HISTORIC PRESERVATION BOARD STAFF REPORT

403 N. Swinton Avenue

| Meeting | File No. | Application Type |
|-------------|----------|--|
| May 7, 2025 | 2025-153 | Certificate of Appropriateness and Level 1 Application |

The item before the Board is consideration of a Certificate of Appropriateness (2025-153) and Level 1 application for exterior modifications to a contributing commercial structure located at **403 N. Swinton Avenue, Del-Ida Park Historic District**.

Proposed plan with the 2 new windows

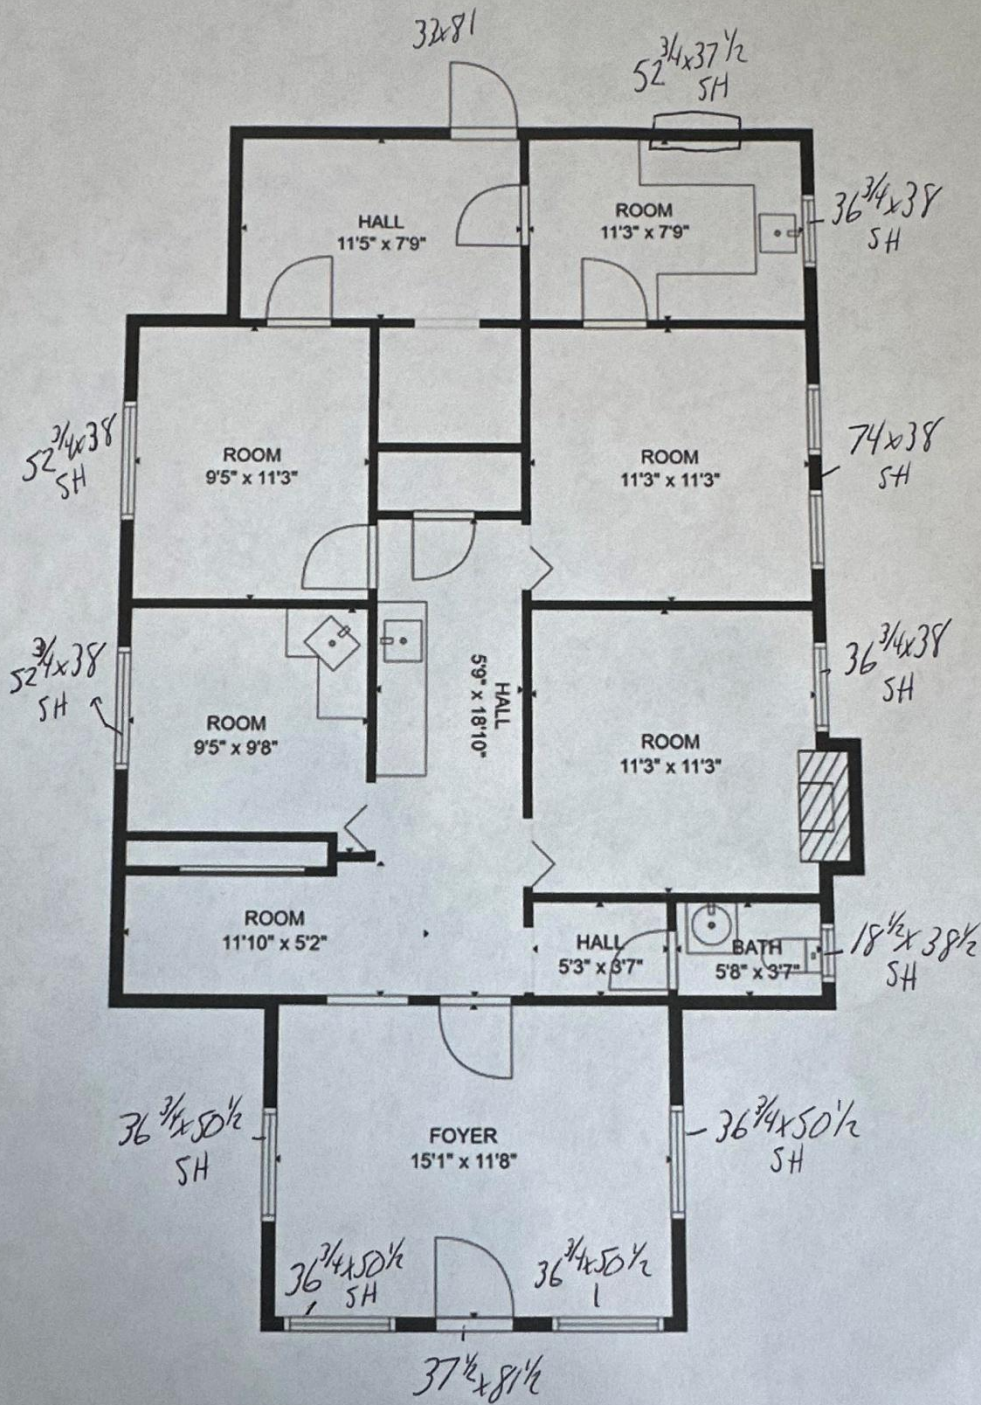
The request also includes the installation of two windows along the north elevation and installation of gable vents where they once existed on the north and south elevations. As previously mentioned, the 1970 building permit shows that there was an additional window in the rear, that doesn't exist today, on the north elevation, shown on the floor plan. The proposed rear window can be considered a restoration of the original window opening on the north elevation.

The 2 new Windows on the North Side will be in the same placement and size as the 2 windows on the south side (Lake Ida Rd) so the property will have uniform windows on each side where they are added.
(the small windows to the Left of the Chimney and the far right window)
